TECHNICAL NOTE

Job Name: Charlie Ratchford Extra-Car Scheme
Job No: 31103
Note No: 02
Date: 20/04/2015
Prepared By: Stephanie Yu
Checked By: Manu Dwivedi
Subject: Response to Comments raised by LBC Highways

This note is prepared in response to the comments received by London Borough of Camden, Highways in relation to the Transport Statement submitted in support of the planning application reference 2015/0921/P.

Figure 1 Submitted Ground Floor Layout as part of the Planning Application (Pg 40 of the DAS)

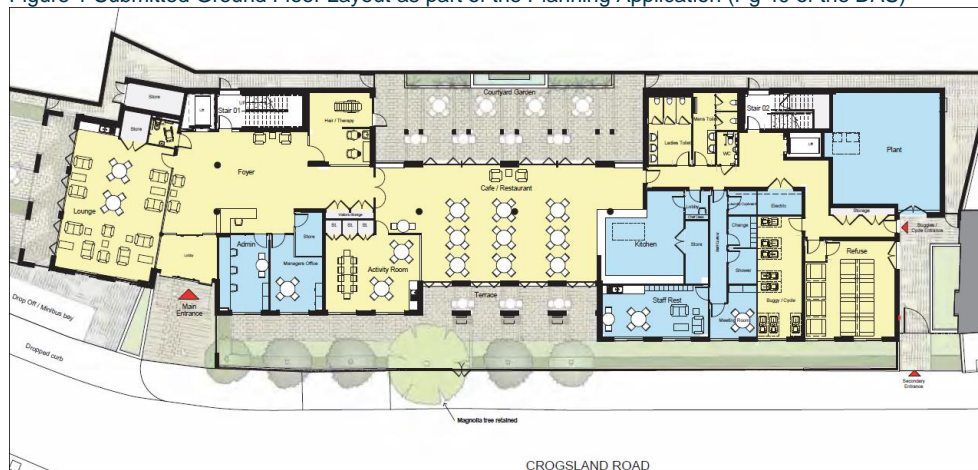
LBC is concerned that it is unclear how many cycle parking spaces are proposed for residents, staff and visitors. The transport statement suggests that cycle parking facilities would be provided in a store room at ground floor level. However, the proposed ground floor plan indicates that the store room would be used to accommodate mobility scooter parking.

A total of eight mobility scooter parking bays are proposed in the store room accessed via the buggies/ cycle entrance. There were spaces in between the marked mobility scooter parking bays which were proposed to be designed as Sheffield stands for staff as required. A reconfigured mobility scooter parking has been proposed which facilitates provision of three Sheffield stands catering to four cycle parking spaces. This should be sufficient for any residents and staff cycle parking spaces. Additionally a total of four cycle parking spaces are proposed adjacent to the main entrance. These are indicatively marked on Figure 3 at this stage but will be designed during the detailed stages.

Adjacent to this room are changing and shower facilities accessed through the staff corridor. Figure 1 below presents the submitted ground floor layout as part of the planning application; Figure 2 presents the reconfigured layout to facilitate six cycle parking spaces and Figure 3 presents the indicative location for two visitor spaces adjacent to the main entrance.

Drawing Number
31103/001/006

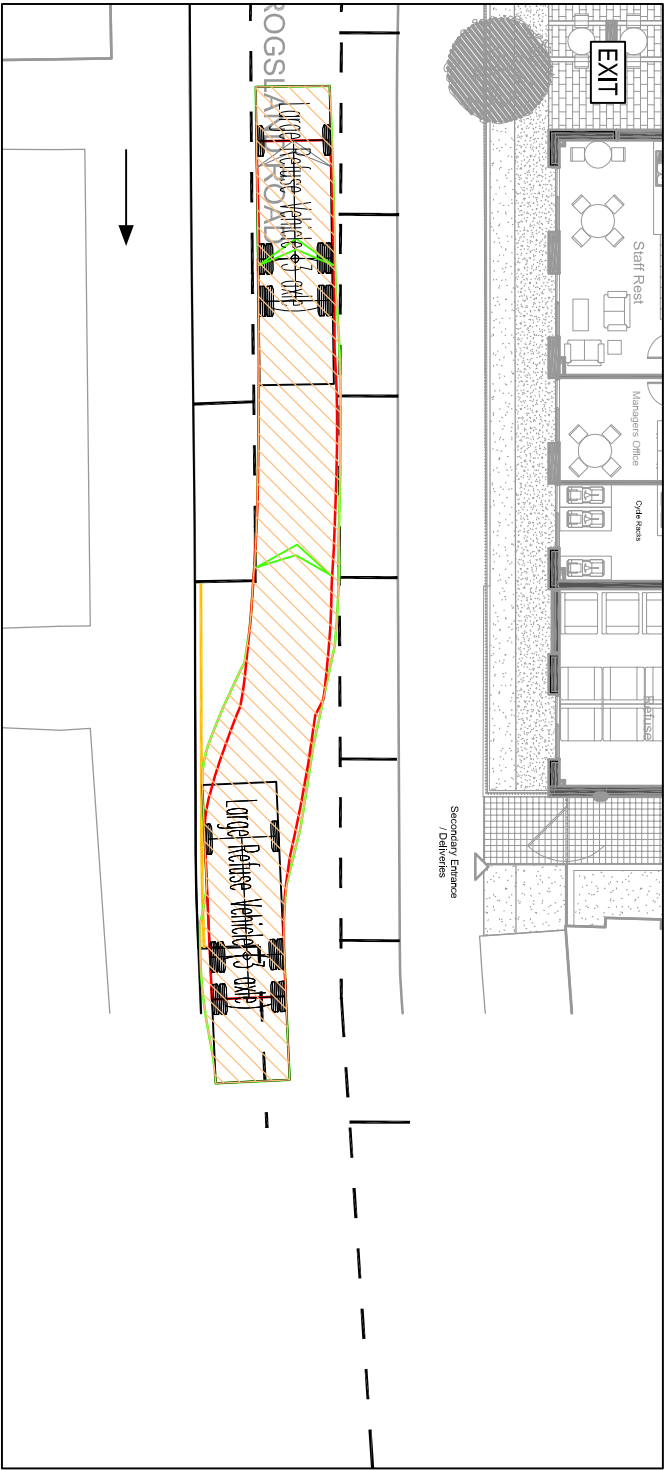
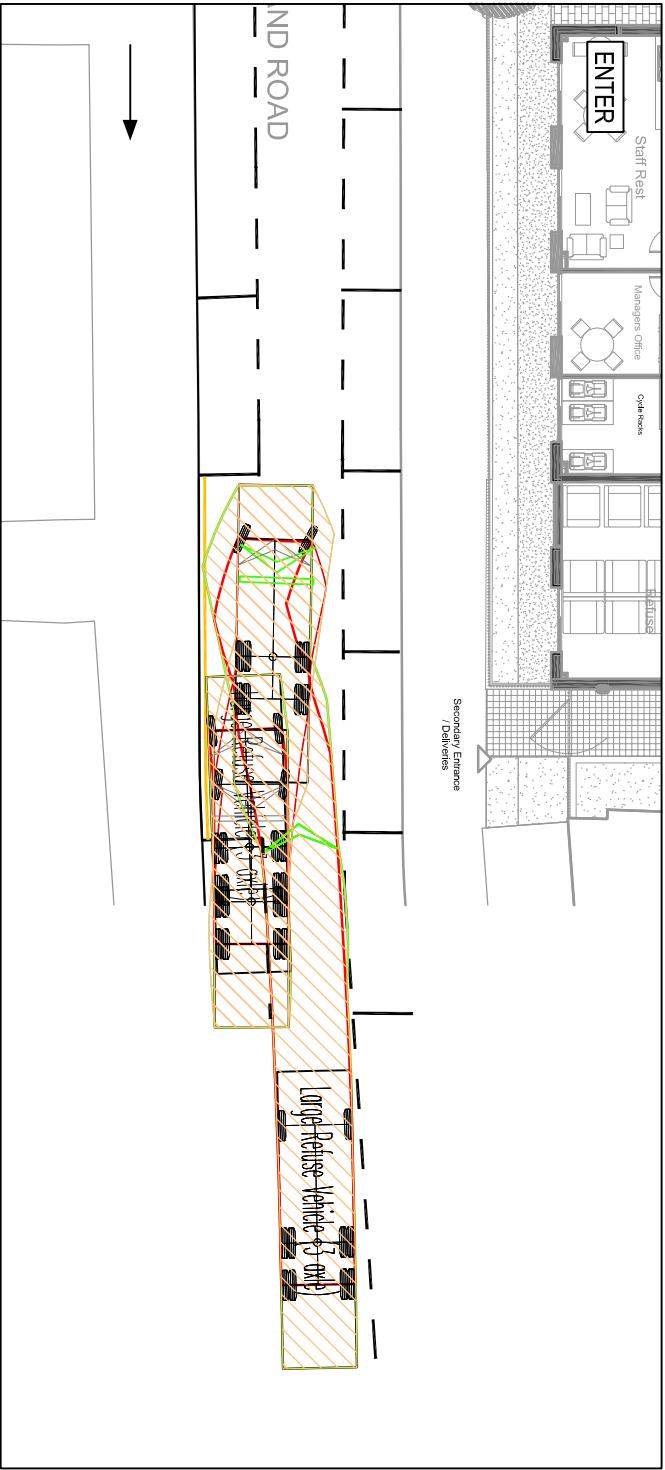
The reasons for reductions in minibus use are unclear. The existing Charlie Ratchford centre appears to have capacity for 2 or 3 minibuses to be in attendance at any one time. However, the proposed scheme would only have capacity for one minibus to be in attendance at any one time. Any more than one minibus being in attendance at any one time would lead to traffic problems in the general vicinity of the site.

A managed system of mini-bus arrival and departure is proposed. Three mini-buses served the site at Belmont Street as presented in Section 2.6 of the submitted Transport Statement. It is proposed that instead of all three mini-buses arriving at the same time, their arrival will be staggered by approximately 15-20 minutes. This will ensure that with a boarding/ alighting time of 10 minutes, there will never be a bus waiting to access the pick-up/ drop-off bay and this will ensure that there is no impact to the traffic on Crogsland Road. If however two mini-buses do arrive at the same time due to traffic related delays, one mini-bus can wait on the carriageway adjacent to the mini-bus picking up or dropping off passengers. The carriageway width at that location is 4.6m and even if one minibus (width 2.2m) is waiting on the carriageway, one medium sized vehicle (width 1.7m) can pass through adjacent to the waiting mini-bus. This is demonstrated in Drawing 33103/001/006.

Date of 1st Issue	20/04/2015	Drawn by	AI
1:250		Checked by	MD
Drawing Number	31103/001/005	Revision	-

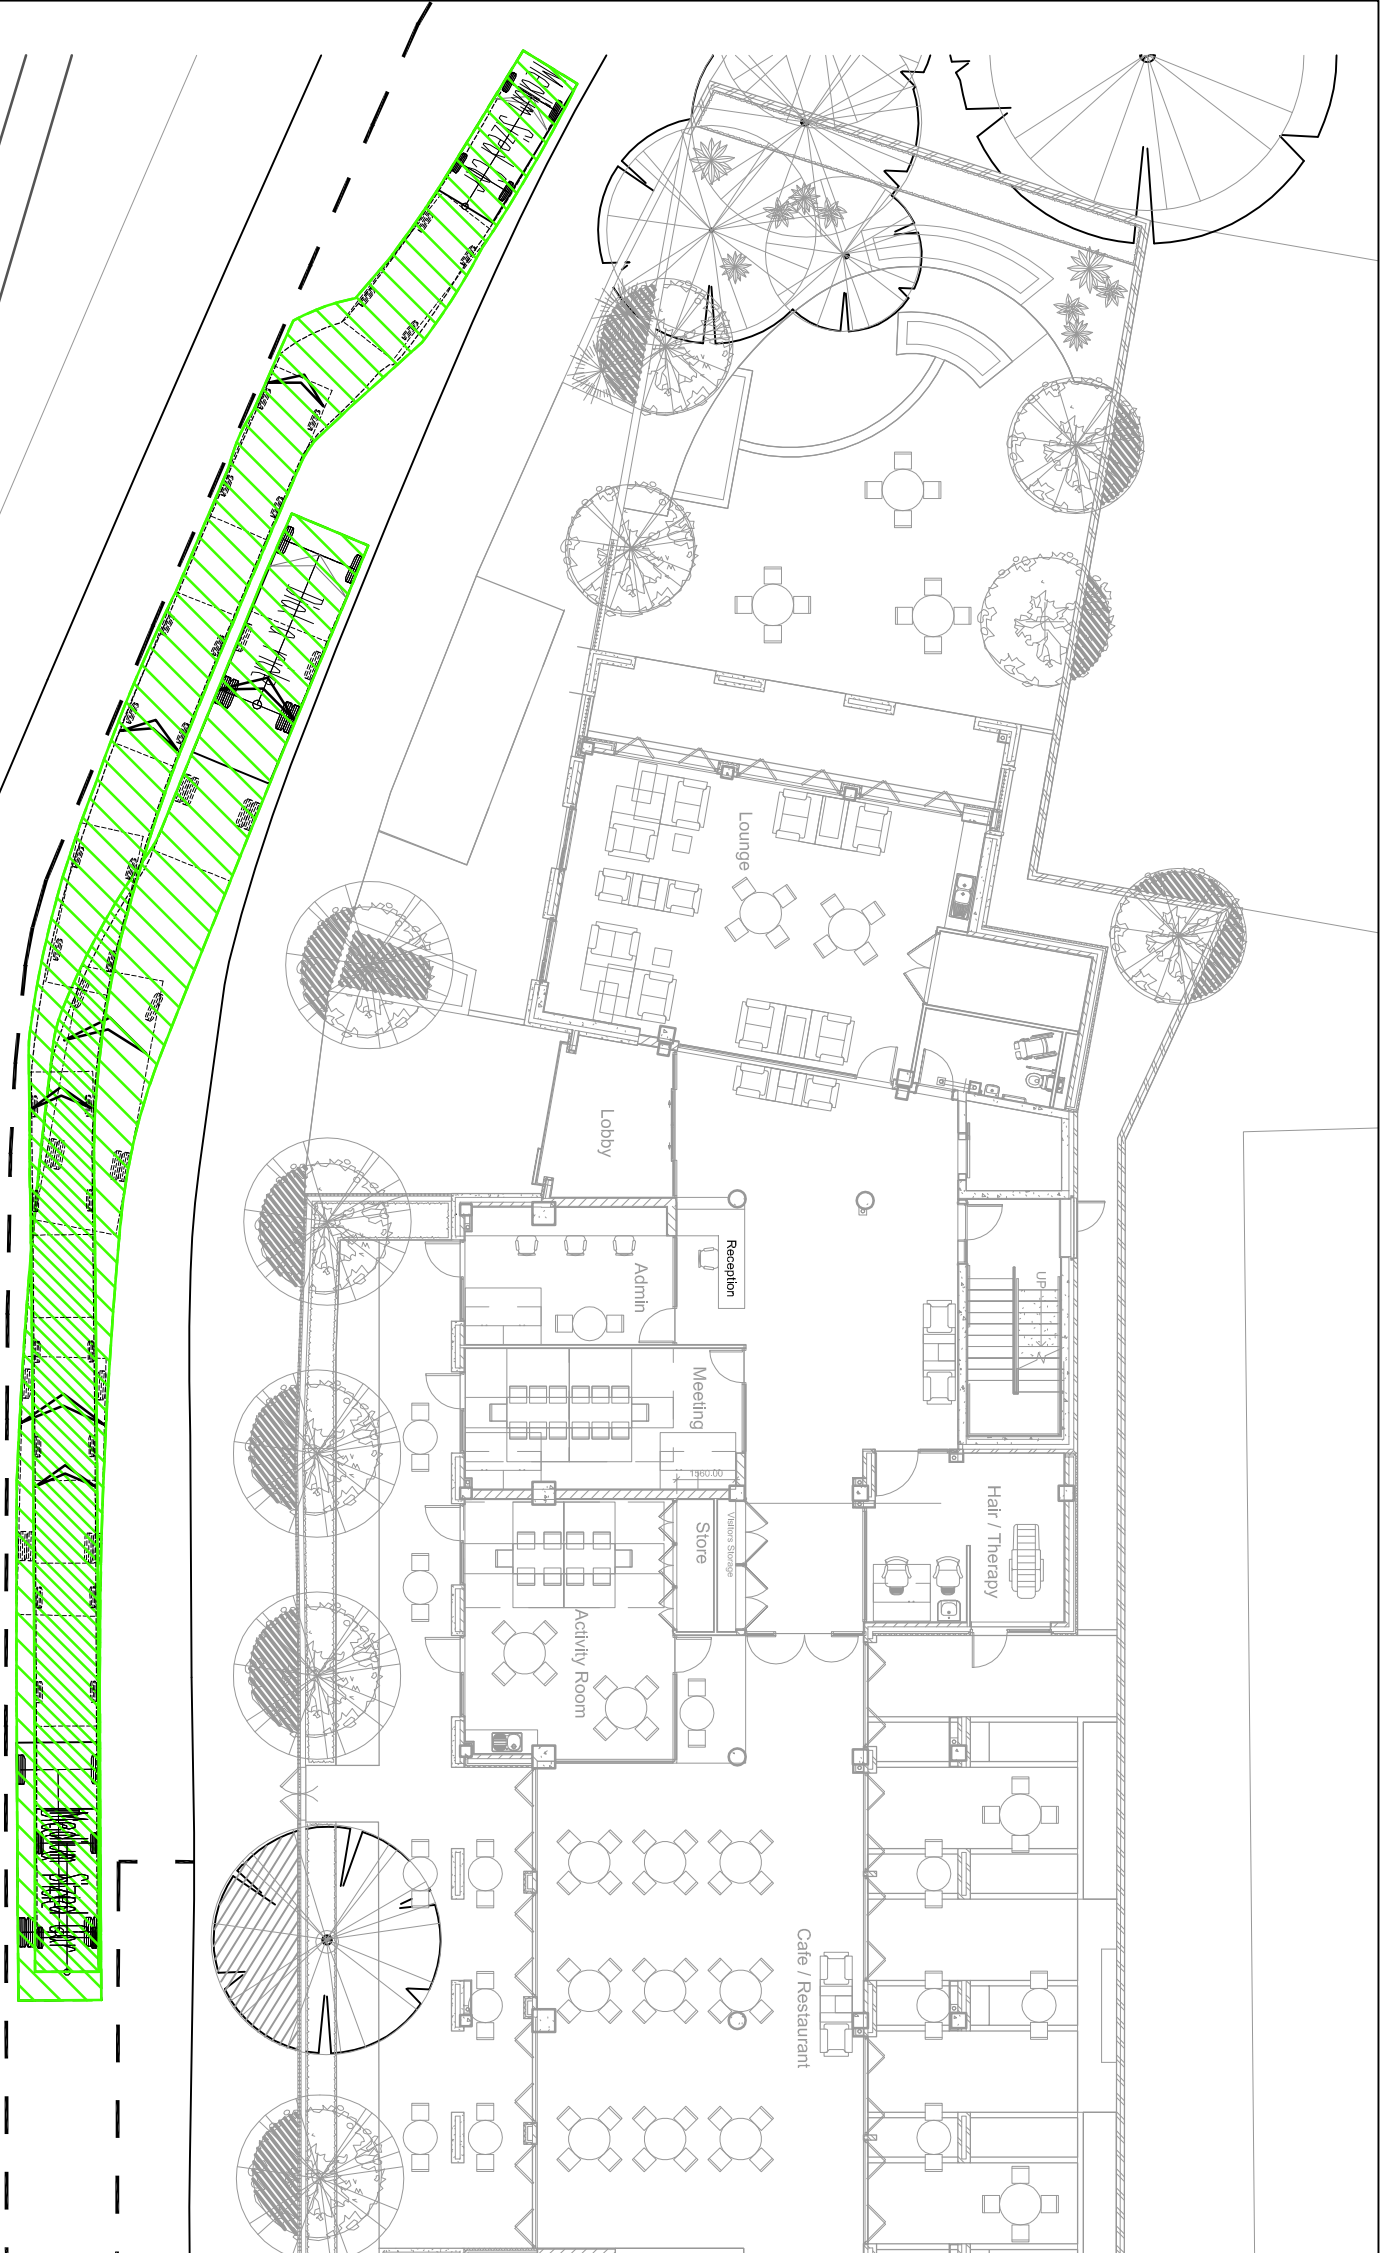
LBC have queried the details of the proposed deliveries and servicing. The transport statement stated that deliveries and servicing activity could be facilitated from single yellow lines directly adjacent to the north-eastern corner of the site. However, it is noted that residents parking bays are currently provided at this location. LBC suggested that deliveries and servicing activity could be facilitated from the single yellow line on the east side of Crogsland Road, directly opposite the north-eastern corner of the site. Otherwise, a new section of single yellow line would need to be introduced on the west side of Crogsland Road, directly opposite the north-eastern corner of the site.

PBA Response: Appendix I of the submitted transport statement effectively presented two options of servicing the site. One of the options was to service from on-street location, like the present waste collection arrangements for residential properties towards the north of Crogsland Road. This will lead to no loss of parking spaces but will cause minor delay to few vehicles while the collection is being conducted. The other option was to collect waste from reconfigured single yellow lines which will lead to a loss of three parking bays which can be provided elsewhere if required, as stated within the Appendix I. LBC have suggested that the eastern side of the carriageway could potentially be used for waste collection. Initially this option as not considered as the refuse collection personnel will have to cross the road and the bins will have to be wheeled back across which may cause some delay to the traffic. PBA have conducted swept path analysis on this option and it will require loss of one parking space on the western carriageway which can be reprovided if required as demonstrated in Appendix I of the Transport Statement. The Drawing 31103/001/005 presents the swept path analysis for the potential waste collection from the western side of the carriageway and Appendix I from the Transport Statement has been appended again for consistency.

Figure 1 Option1 for Proposed Mini-Bus Parking Bay

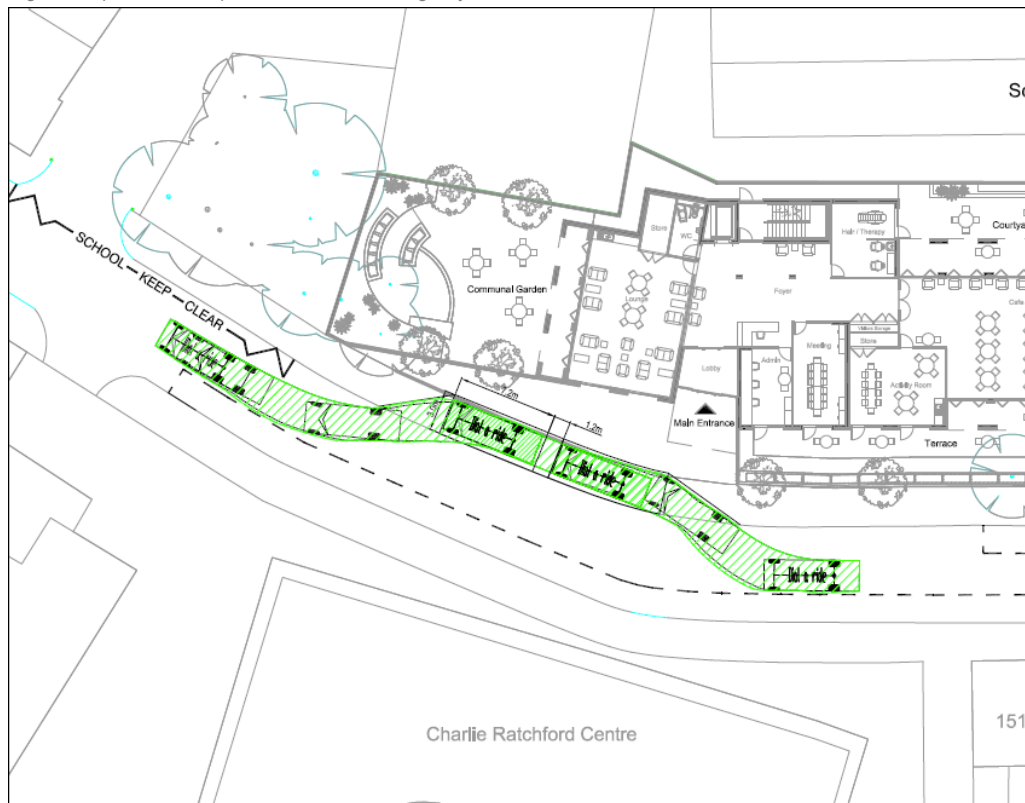
- Facilities for PTS vehicle pick up and drop off movements should be designed within the site and that PTS vehicles would need to be able to exit the site in a forward gear.
- The idea of 2 vehicular crossovers (1 in and 1 out) was not supported as this would remove on-street parking outside of CPZ operating hours.
- The applicant agreed to do a parking beat survey to assess existing levels of parking stress.
- An inset loading bay was not supported as this would hinder pedestrian movement when occupied (pedestrians would need to deviate from the existing desire line).
- An on-street loading bay was not supported as this would obstruct vehicular traffic on Crogsland Road. The applicant advised that they wouldn't want an on-street facility as people likely to be using the PTS vehicles would feel too vulnerable being so close to pedestrians and vehicular traffic.

Options for providing a PTS loading bay on site have been explored. These are presented in Figures 1 and 2 for Options 1 and 2 respectively. In Option 1, two bays can be provided however the footway is on the wrong side of where passengers will be alighting or boarding. As can be seen, Option 2 presents the bay provided within the site and a vehicle can reverse into the bay and exit in forward gear. Therefore Option 2 was taken forward in further design development of the proposed site.
